Rule: 2011-024-MIS-NR

SUBJECT: Exide Battery Recycling Plant
Frisco, Texas
Project No. 2011-024-MIS-NR.

We have been asked by Jim Mallett to review the Proposed 2011 Collin County Attainment Demonstration State Implementation Plan (“SIP”) Revision for the 2008 Lead National Ambient Air Quality Standard (“NAAQS”) (2011-001-SIP-NR), and also the associated Proposed Agreed Order (2011-024-MIS-NR).

Figure 1
Exide Technologies - Frisco, Texas
Lead Emissions and Ambient Air Lead Concentrations

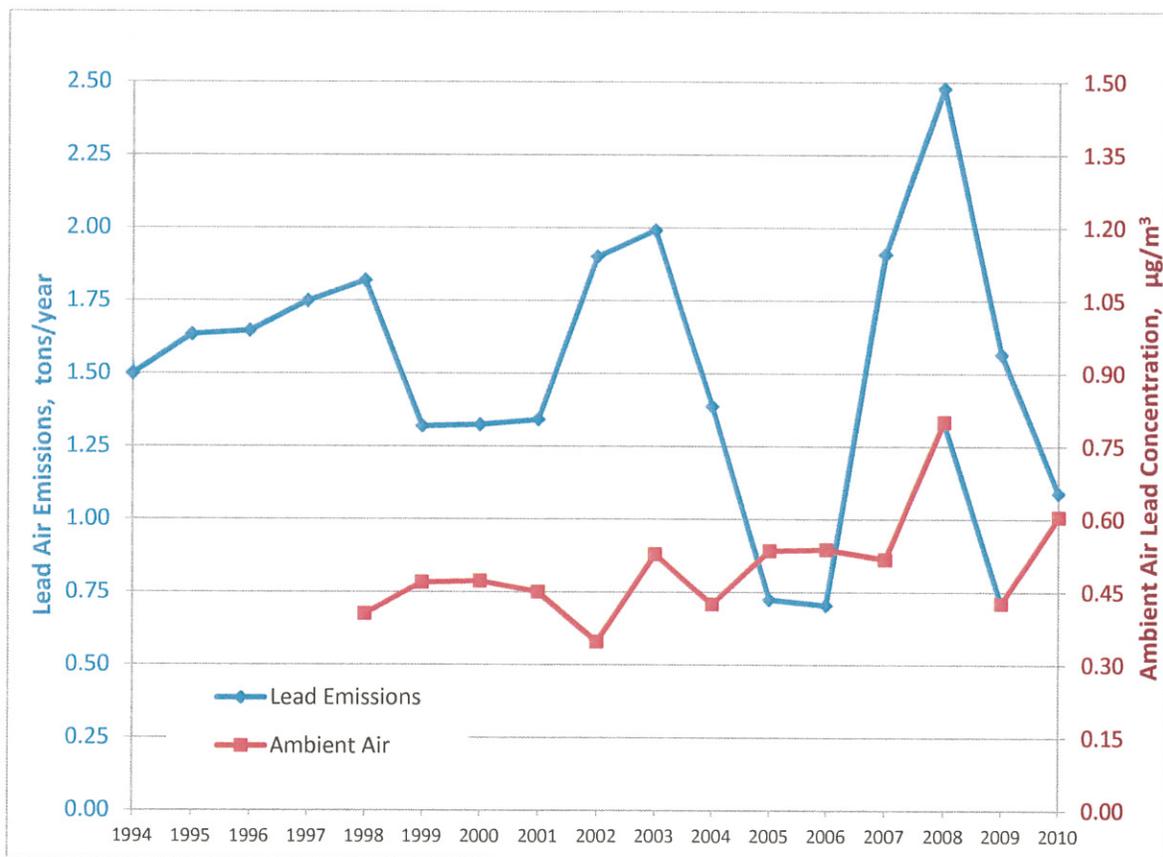
We reviewed the historic Exide Frisco Plant emission inventories and observed that the reported data did not appear to be consistent. The lead emission inventory data for 1994 – 2010 is shown on Figure 1. All of the data except for 2010 was taken from the EPA Toxic Release Inventory (“TRI”) data.

This figure also shows the Frisco area ambient air lead concentrations for 1998 – 2010. This data is for the monitor located to the north of the Exide site, (Monitor No 480850009). We took the four quarterly averages for the year and averaged the data for the annual concentration shown.

Note that the data suggest that the emission inventory data for 2005 and 2006 are grossly underestimated, as the ambient air concentrations do not drop. The ambient air concentrations would have been expected to be much lower. In addition, note that the ambient air concentrations of lead are trending upward.

Based upon the data presented and to ensure the TCEQ presents an accurate Lead NAAQS attainment demonstration, we recommend that the TCEQ remodel the lead attainment demonstration and use a background lead concentration of between $0.03 \mu\text{g}/\text{m}^3$ and $0.10 \mu\text{g}/\text{m}^3$. When the background lead concentration is added to the TCEQ's demonstrated ambient air lead concentration, the result is $0.177 \mu\text{g}/\text{m}^3 - 0.247 \mu\text{g}/\text{m}^3$. These concentrations are well above the 2008 Lead NAAQS of $0.150 \mu\text{g}/\text{m}^3$. Even taking the lowest recommended background lead concentration of $0.028 \mu\text{g}/\text{m}^3$, and adding this to the TCEQ's maximum modeled concentration, results in a total lead concentration of $0.175 \mu\text{g}/\text{m}^3$, still well above the Lead NAAQS.

Figure 2
PM_{2.5} High 8th High for 2010

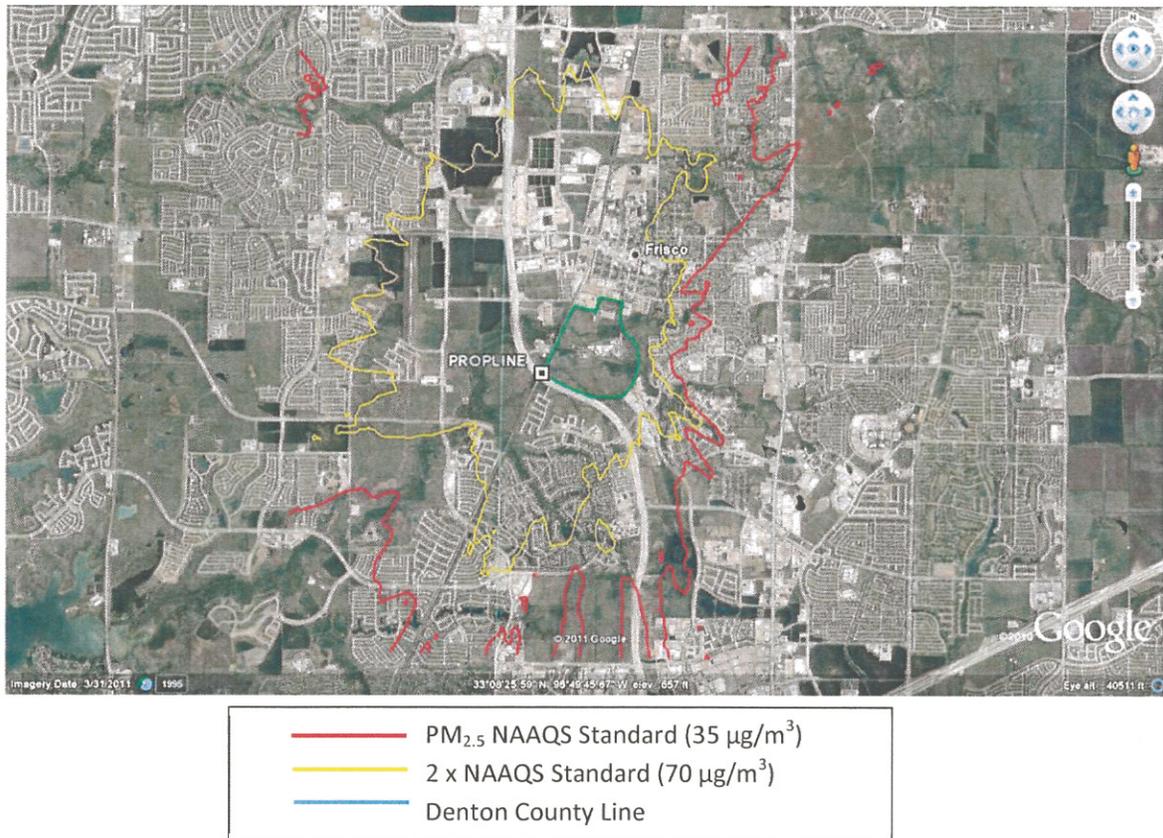
This table demonstrates that the area around the Exide Frisco Plant is also nonattainment for PM_{2.5} due to the PM_{2.5} emission sources from Exide. As shown on Figure 2, the nonattainment area extends into Denton County.

The point source parameters and emission rates are summarized in Table 9. The area source parameters and emission rates are summarized in Table 10. A plot of the PM_{2.5} nonattainment area for 2010 is included as Figure 2.

Figure 3
SO₂ High 4th High for 2010

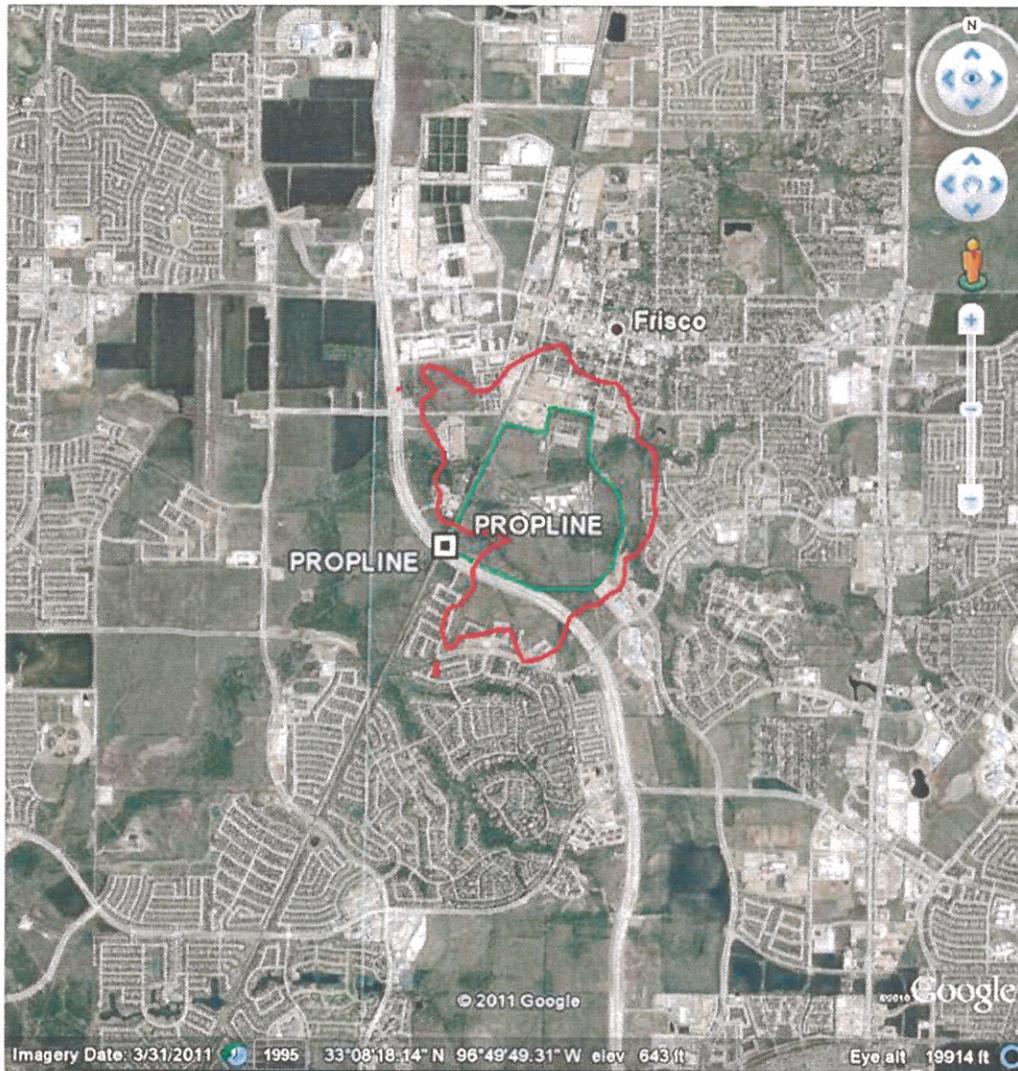
This table demonstrates that the area around the Exide Frisco Plant is also nonattainment for SO₂ due to the emission sources from Exide.

The point source parameters and emission rates are summarized in Table 12 below. The area source parameters and emission rates are summarized in Table 13. A plot of the SO₂ nonattainment area for 2010 is included as Figure 3.

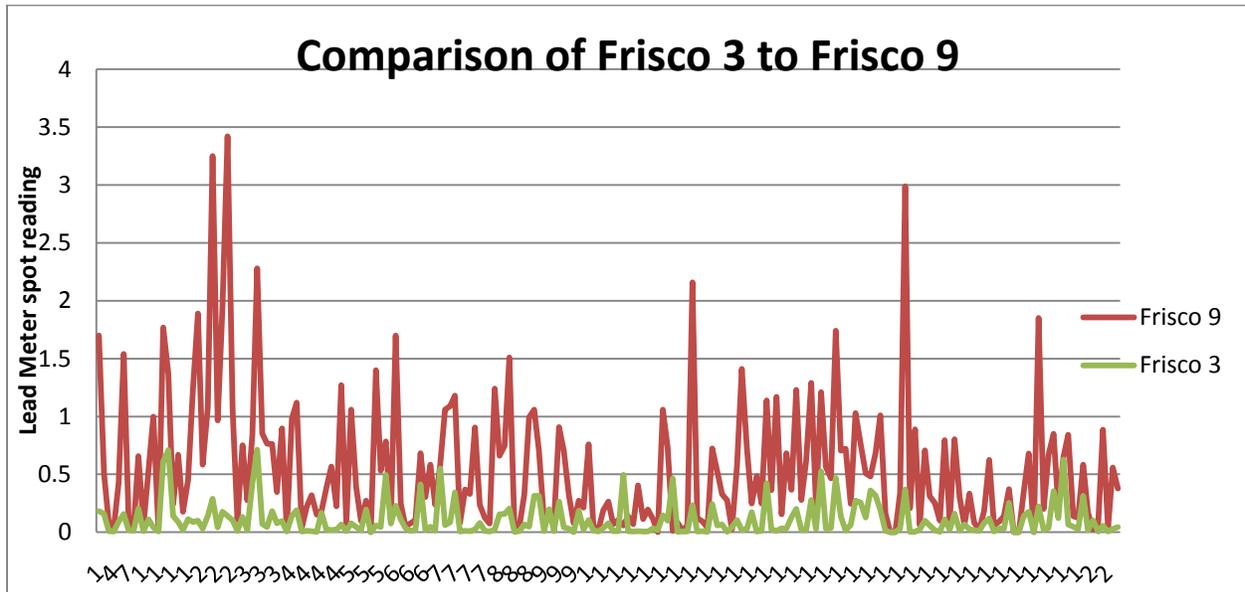
I would like to discuss the monitoring locations. Specifically 480850009 (Monitor C – Frisco 9) and 480850003 (Monitor B – Frisco 3). All 4 of the Frisco lead monitor work in the same way and on the same day. Each monitor's sampler opens for 24 hours every 6 days. Due to the close proximity of the two monitors the data from them is highly correlated. A high reading on Frisco 3 will most likely indicate a high reading on Frisco 9. Below is a graph of the readings over the past few years.

The correlation of the two data sets is 0.50838719

A few things to note from the graph:

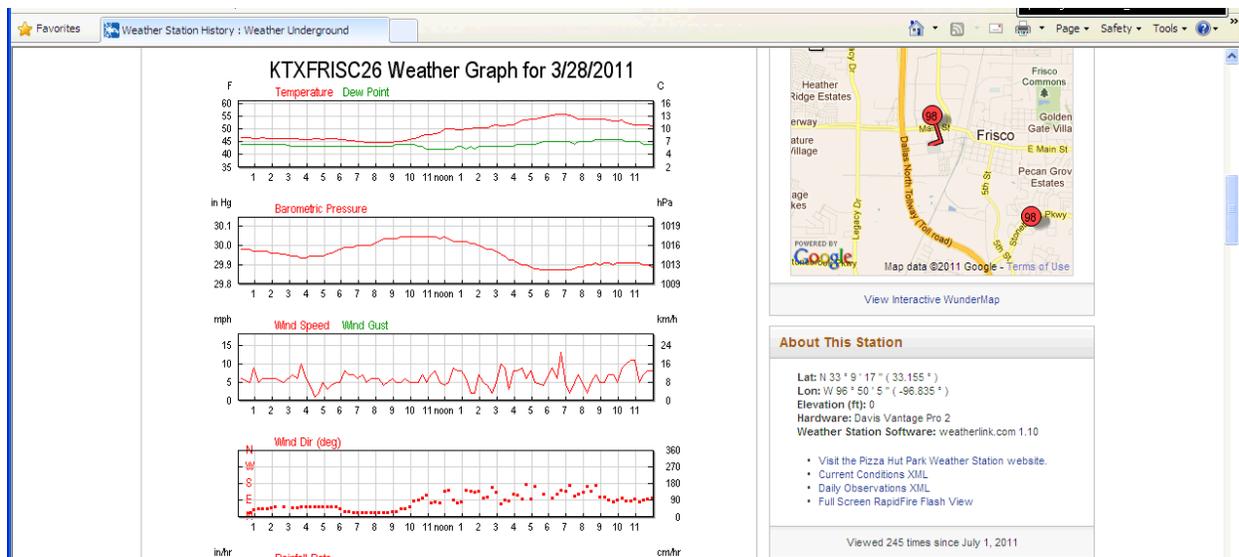
1. There are certain plant operations that produce lead emissions - slag transfer, firing the ovens, battery breaking.
2. The monitors are only on 1 day every 6 days.
3. The exact time and date of monitors being turned on and off is a known entity
4. All 4 of our monitors turn on and off at the exact same time and date
5. We even know the wind direction and speed

This methodology enables gaming the monitoring system, the plant can game the monitors by restricting high lead risk activities to the 5 out of 6 days when the monitors are not sampling.
